TO: Mayor Khalid Kamau, City of South Fulton
ATTN TO: Reginald McClendon, Managing Director, Community Development, City of South Fulton
FROM: Mike Alexander, COO, Atlanta Regional Commission
RE: Development of Regional Impact (DRI) Review

Name of Proposal: Vantage Data Center – Stacks Road DRI 4257

VANTAGE DATA CENTER – STACKS ROAD DRI
City of South Fulton
Natural Resources Review Comments
February 10, 2025

SCALE: 1" = 60'
DATE: 10/14/2024
DRAWN BY: BA
CHECKED BY: BA
PROJECT MANAGER: BILL AGUILAR
PROJECT #: 23-220019
SHEET EX1.0

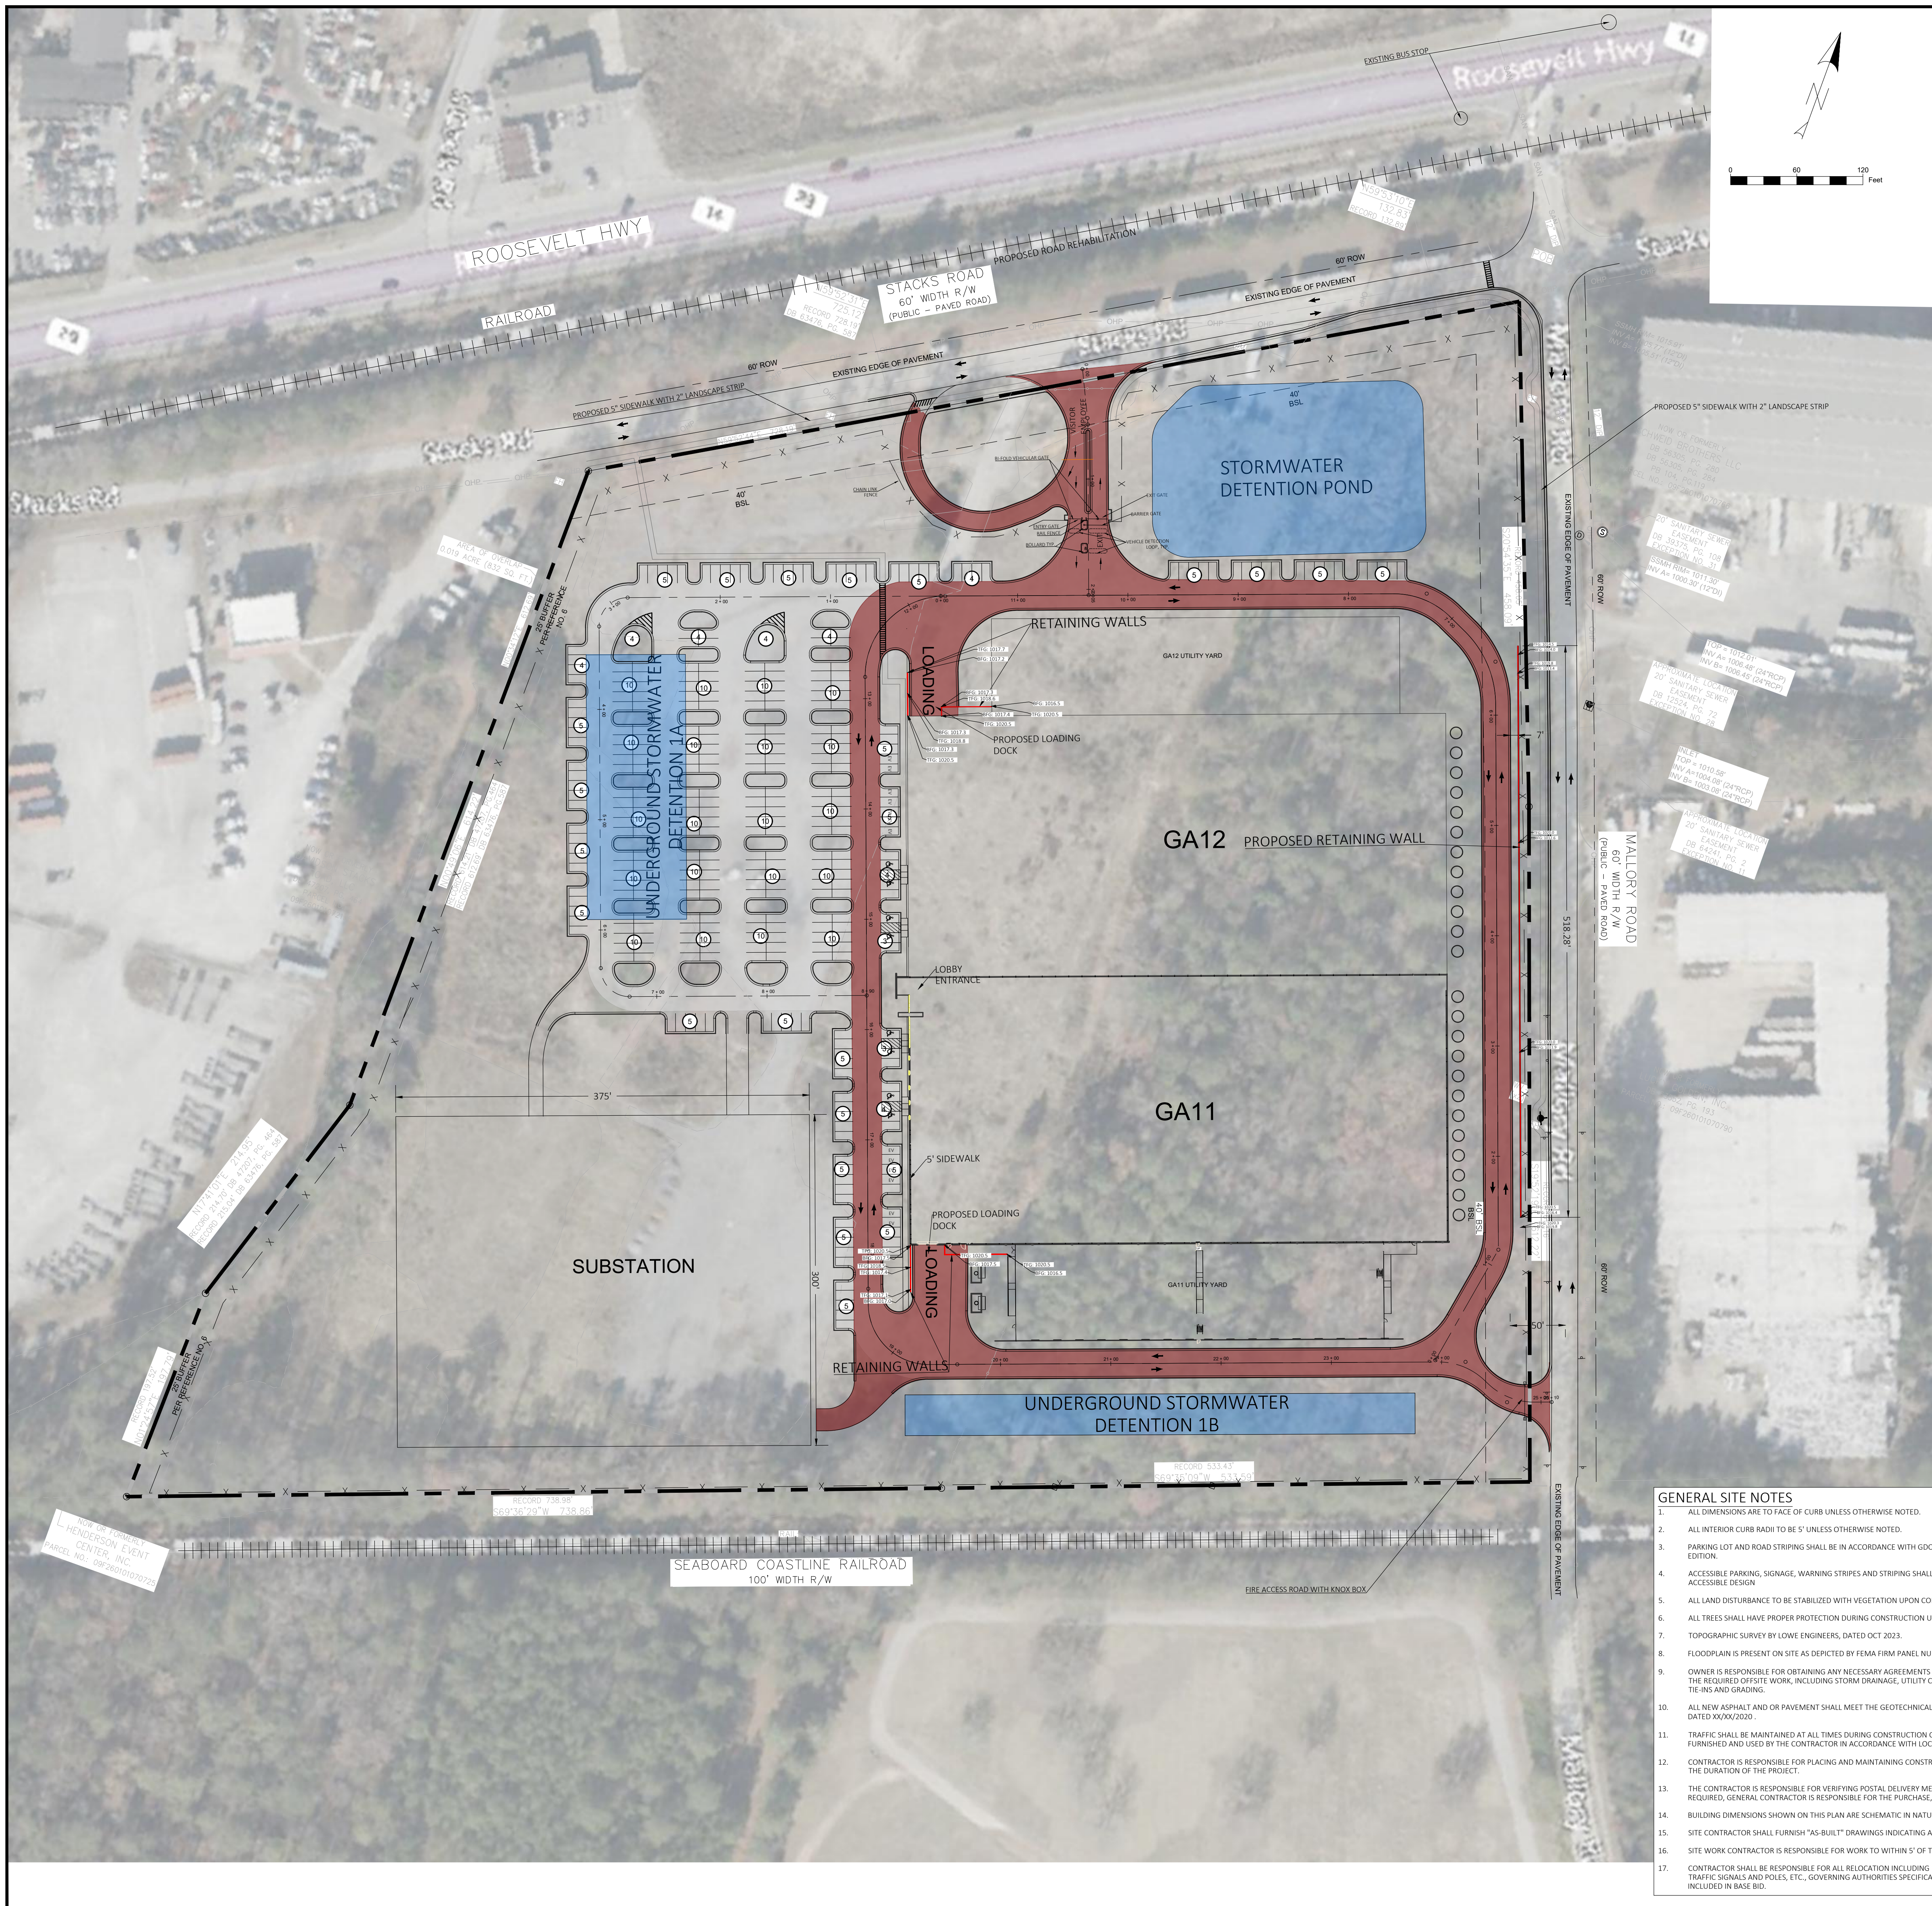
As flooding in the region becomes an increasing concern, every effort should be made to reduce flooding risks to lives and property. The site plan shows portions of the proposed substation within the mapped FEMA Flood Zone X although the flood plan limits are not shown on the site plan. All site plans must show any designated floodplains so their impact on the project can be determine. Development within the floodplain areas will need to meet all applicable requirements under the City's existing and future floodplain ordinances.

Neither the USGS coverage for the project area nor submitted site plan show any streams on the project property. Any unmapped streams on the property may also be subject to the City buffer requirements. Any unmapped State waters identified on the property may also be subject to the State 25-foot Sediment and Erosion Control buffer.

Although there are no streams on or near the property, the FEMA floodplain map for the project area shows an area of Flood Zone X, or the 500-year floodplain in the southwestern portion of the property. It is not shown on the site plan. As defined by FEMA, Flood Zone X is primarily for the 500-year floodplain (0.2% annual flood chance hazard) but it also includes areas of 1% annual chance flood (100-year floodplain) with average depth less than one foot or with drainage areas of less than one square mile. The site plan shows portions of the proposed substation within the mapped Flood Zone X. Development within the floodplain areas will need to meet all applicable requirements under the City's floodplain and future floodplain ordinances.

Although there are no streams on or near the property, the FEMA floodplain map for the project area shows an area of Flood Zone X, or the 500-year floodplain in the southwestern portion of the property. It is not shown on the site plan. As defined by FEMA, Flood Zone X is primarily for the 500-year floodplain (0.2% annual flood chance hazard) but it also includes areas of 1% annual chance flood (100-year floodplain) with average depth less than one foot or with drainage areas of less than one square mile. The site plan shows portions of the proposed substation within the mapped Flood Zone X. Development within the floodplain areas will need to meet all applicable requirements under the City's floodplain and future floodplain ordinances.
